**THE CITY OF THE VILLAGE OF DOUGLAS
PLANNING COMMISSION
THURSDAY, JULY 09, 2026 AT 6:00 PM
415 WEST WILEY RD, SUITE 103, DOUGLAS, MI
49406**

To: City of the Village of Douglas Planning Commission
Date: June 22, 2026
From: Sean Homyen, Planning & Zoning Administrator
RE: 86 W. Center St – Special Land Use Request for Hotel/Motel (Section 26.23)

ADDITION & ALTERATIONS
THE DUTCHER HOTEL
1875 HOSPITALITY GROUP, LLC
86 CENTER ST., DOUGLAS, MICHIGAN 49406

LANDSCAPE PLAN
SCALE: 1" = 10'

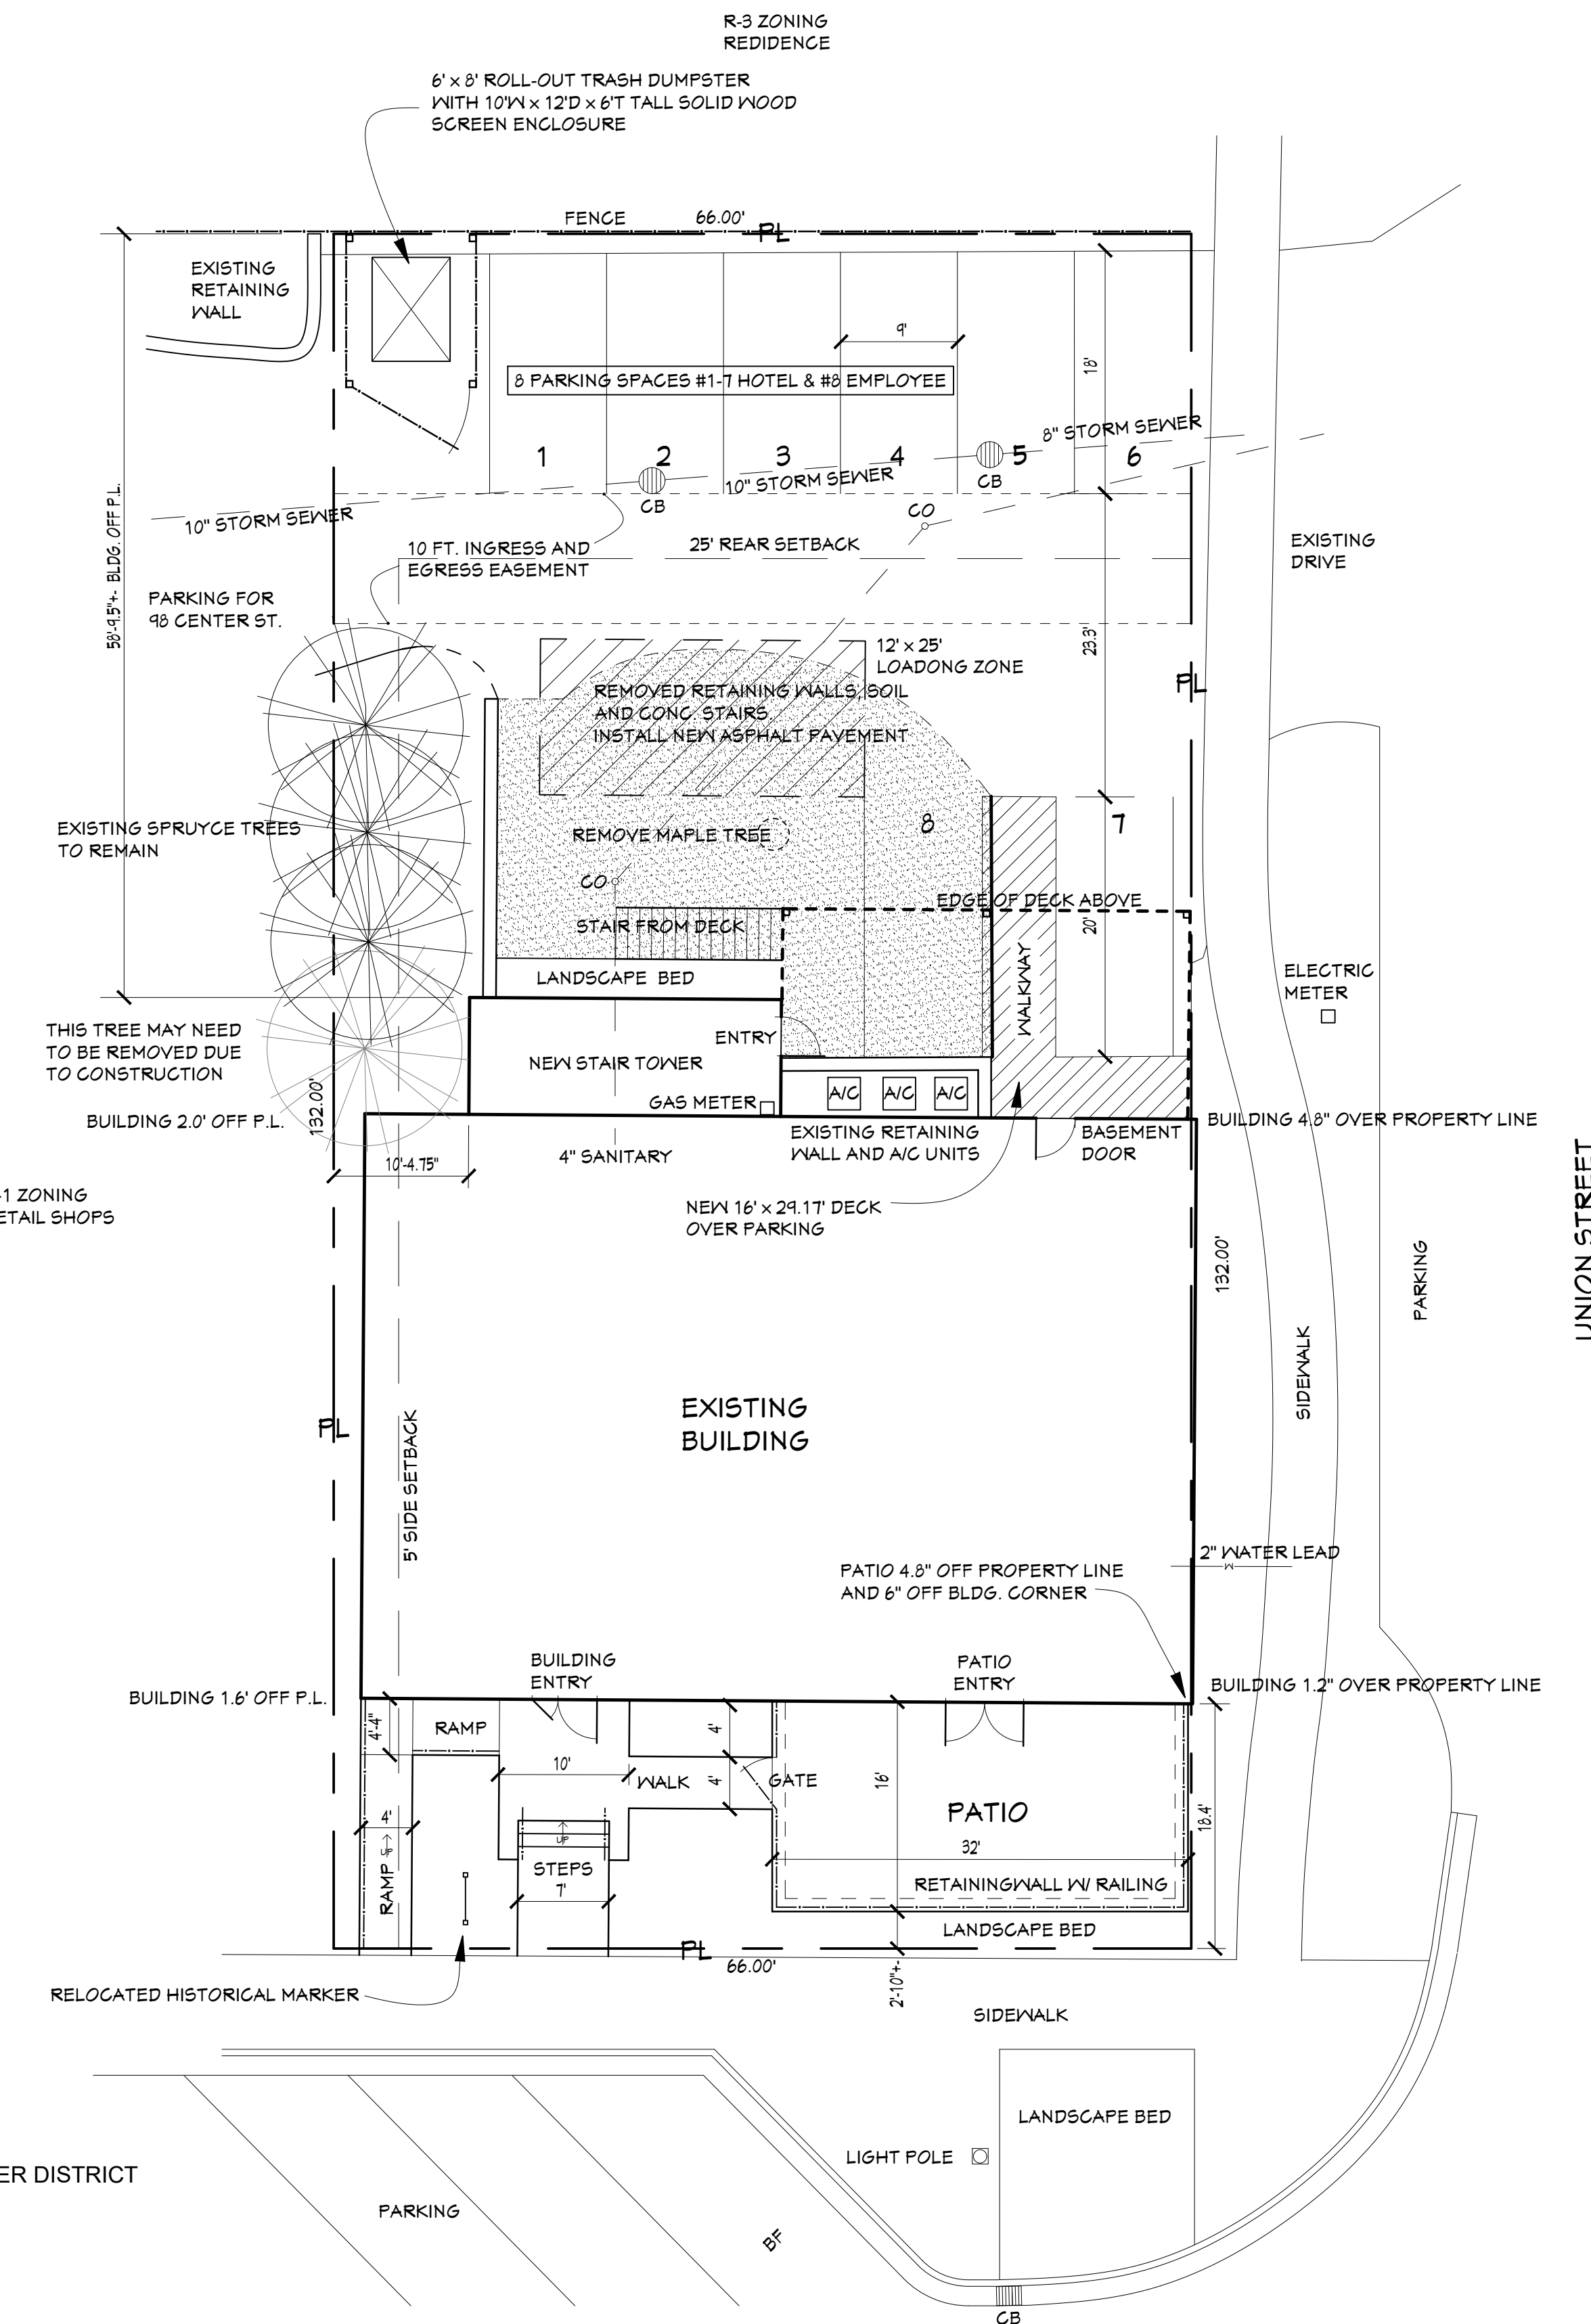
Remarks. Landscaping is provided in the front yard along Center Street. Landscaping is also proposed along Union Street; however, portions are located within the public right-of-way. After discussion with the DPW, landscaping within the public right-of-way should be removed. The site plan shall be revised accordingly.

Remarks. Due to the existing building placement and limited available space along Union Street and Center Street, planting additional street trees may not be feasible. The Planning Commission shall determine whether there is sufficient space to accommodate the required trees or whether the existing conditions satisfy the intent of this standard.

Remarks. Existing spruce trees are identified to remain on the site plan. Tree protection measures shall be installed during construction in accordance with this section.

Remarks. One tree is proposed to be removed, the Planning Commission shall determine if the tree shall be replaced in the area or in other areas of the property if possible.
